Point Beach Nuclear Plant

Response to Request for Additional Information
License Amendment Request 260
One-Time Extension of Completion Time for
Technical Specification 3.7.5, Auxiliary Feedwater System

LICENSE AMENDMENT REQUEST 260 ONE-TIME EXTENSION OF COMPLETION TIME FOR TECHNICAL SPECIFICATION 3.7.5, AUXILIARY FEEDWATER SYSTEM

RESPONSE TO REQUEST FOR ADDITIONAL INFORMATION

Figure PRA RAI-6.1
CDF and LERF Convergence Study for Unit 1 with P-038A MDAFW Pump OOS

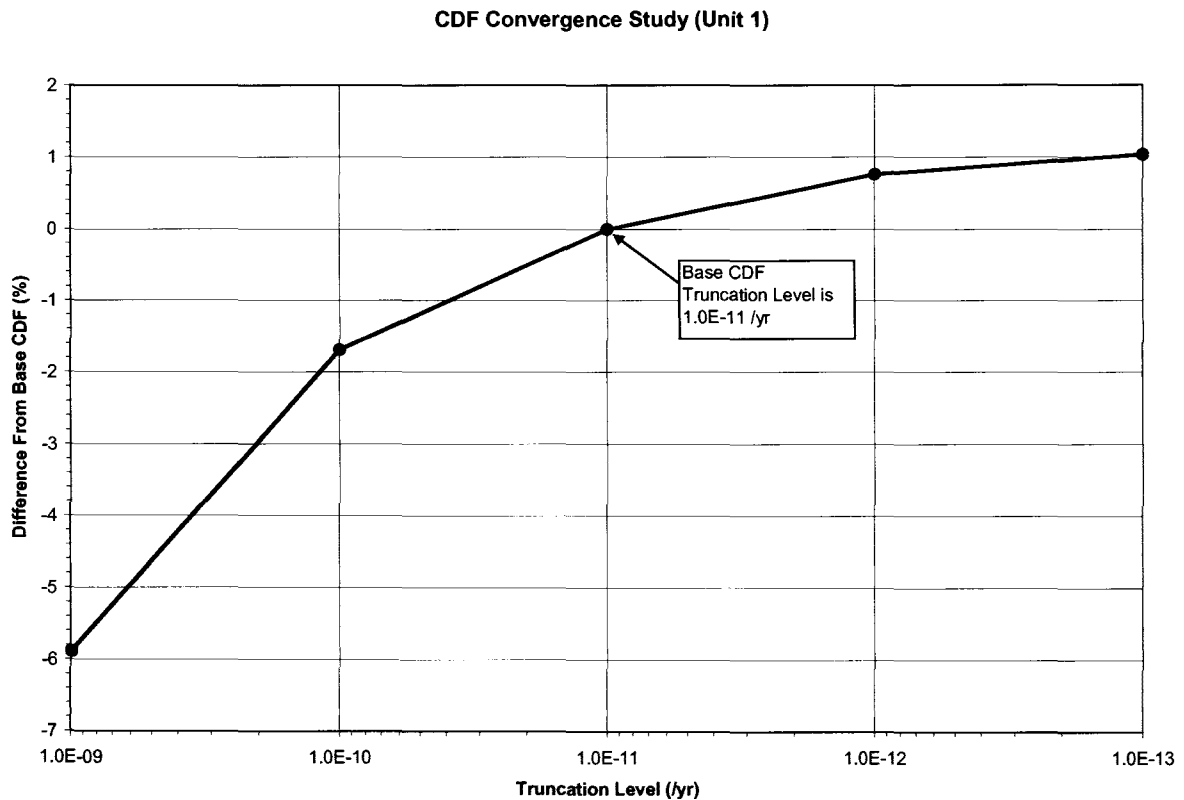
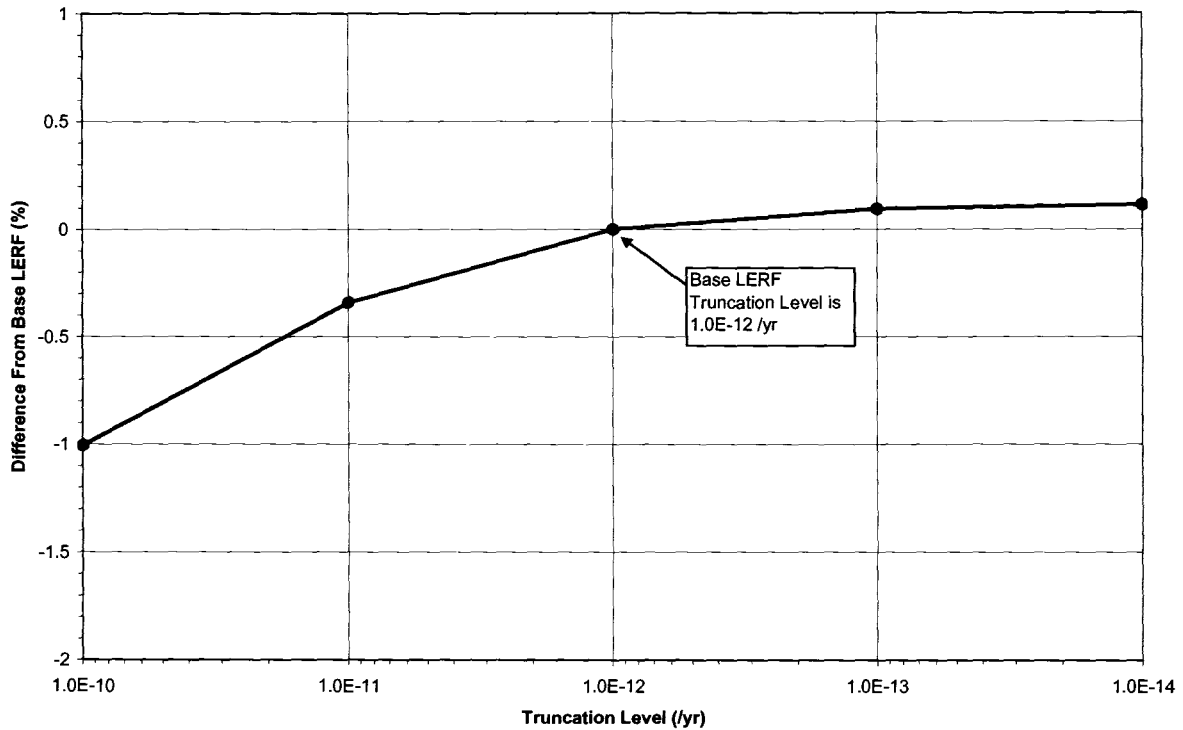
The submittal did not identify and justify the truncation limits applied to the baseline model and to the specific application calculations, per RG 1.177, section 2.3.3.4. The licensee is requested to provide this information.

The truncation limit used in all of the CDF runs was 1.0E-11/yr. For all of the Large Early Release Frequency runs, the truncation limit used was 1.0E-12 /yr. These are the base truncation limits typically used when quantifying the PRA model at PBNP. The cutset manipulation method discussed in RG 1.177, Section 2.3.3.4 was not used for this application. Because new quantifications were explicitly performed with each MDAFW pump failed, one at a time, all important cutsets were retained and the truncation of important cutsets did not occur.

A convergence study was performed to determine the adequacy of these truncation levels for the Unit 1 model while the P-38A MDAFW pump is OOS. Comparable results are expected for the case when the P-38B MDAFW pump is OOS on Unit 1. The Unit 2

model was shown to converge at least as quickly as the Unit 1 model in a study performed for the model quantification summary notebook. As shown in Figure PRA RAI-6.1, approximately 1% of the CDF cutsets are not accounted for when using a $1.0\text{E-}11$ /yr truncation limit for CDF. Approximately 0.1% of the LERF cutsets are not accounted for when using a $1.0\text{E-}12$ /yr truncation limit for LERF.

Based on guidance in NEI 99-02 Revision 5, CDF is considered to be converged when decreasing the truncation level by a decade results in a change in CDF of less than 5%. With the truncation levels used in this application, this criterion is satisfied and the use of the base truncation limits is justified.

Figure AFPB RAI-3.1

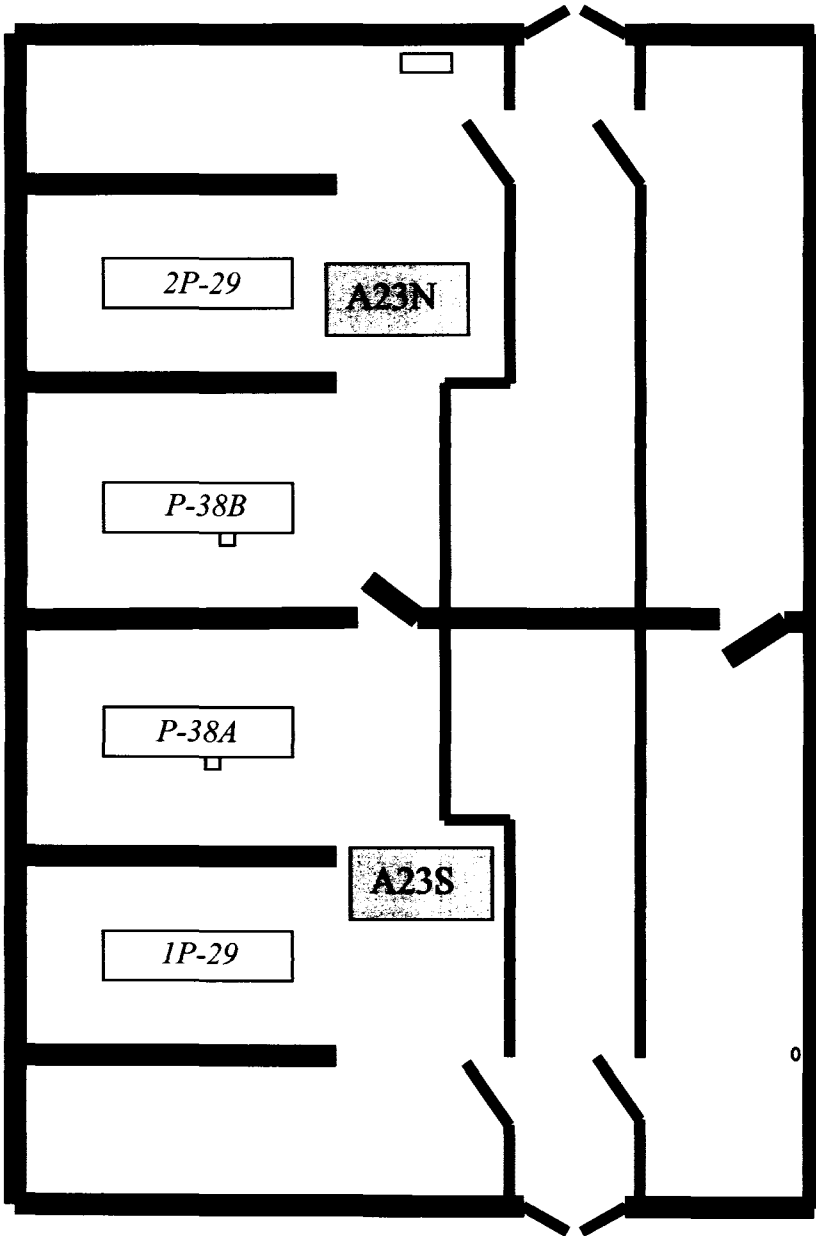
Section 3.2.2.4 states: "This review identified seven fire areas where a fire concurrent with a motor-driven AFW pump being unavailable because of extended replacement activities could result in no AFW pump being available to provide decay heat removal."

For each of these fire areas, please provide the following:

- *A description (type of circuit, location of cables, location of nearby ignition sources, etc.) of those safe shutdown circuits and/or components that could potentially receive fire-induced damage that provide the same functionality as the motor-driven auxiliary feedwater (MDAFW) pumps being removed from service (redundant MDAFW pump, turbine driven AFW pump, etc.)*
- *An evaluation of each of these circuits/components to determine the feasibility of an operator action to address potential fire damage (for motor operated valves and air operated valves, investigate the possibility of local, manual operation) to restore/maintain availability of the redundant system*

A23N: A23N is the north half of the AFW pump room, and is separated by a 3-hour fire barrier from the south half (see Figure RAI-3.1). The Unit 2 TDAFW pump (2P-29) and the "B" MDAFW pump (P-38B) are both located in this room, as are several supporting valves (mini-recirc flow isolation air-operated valves (AOVs), discharge flow control AOV, discharge isolation motor-operated valves (MOVs), and discharge flow control MOVs). Preliminary information from the NFPA 805 transition project has identified safe shutdown off-site power cables in this area. As such, maintaining or recovering offsite power for a fire in this area, or equipment powered from it, is not considered credible. Guidance provided in the plant fire attack plans (FAPs), fire emergency plans (FEPs) and fire organization plans (FOPs) were developed to limit potential fire damage and to enable restoration of the equipment following a fire. As such, restoration of the AFW pumps in the area may be possible.

A23S: A23S is the south half of the AFW pump room, and is separated by a 3-hour fire barrier from the north half (see Figure RAI-3.1). This case is largely symmetric with the one for a fire in A23N. Preliminary information from the NFPA 805 transition project has identified safe shutdown off-site power cables in this area. As such, maintaining or recovering offsite power for a fire in this area, or equipment powered from it, is not considered credible. Guidance provided in the plant fire attack plans (FAPs), fire emergency plans (FEPs) and fire organization plans (FOPs) were developed to limit potential fire damage and to enable restoration of the equipment following a fire. As such, restoration of the AFW pumps in the area may be possible.

Consistent with the assumptions of the SSAR, an all-consuming fire is one which causes 100% functional failure of all electrical equipment in the fire area. A severe exposure fire in either room could directly damage both pumps, their prime movers, and/or the associated supporting valves and controls to the extent that local manual actions are not feasible or are too complicated to be relied upon for near-term recovery of function.
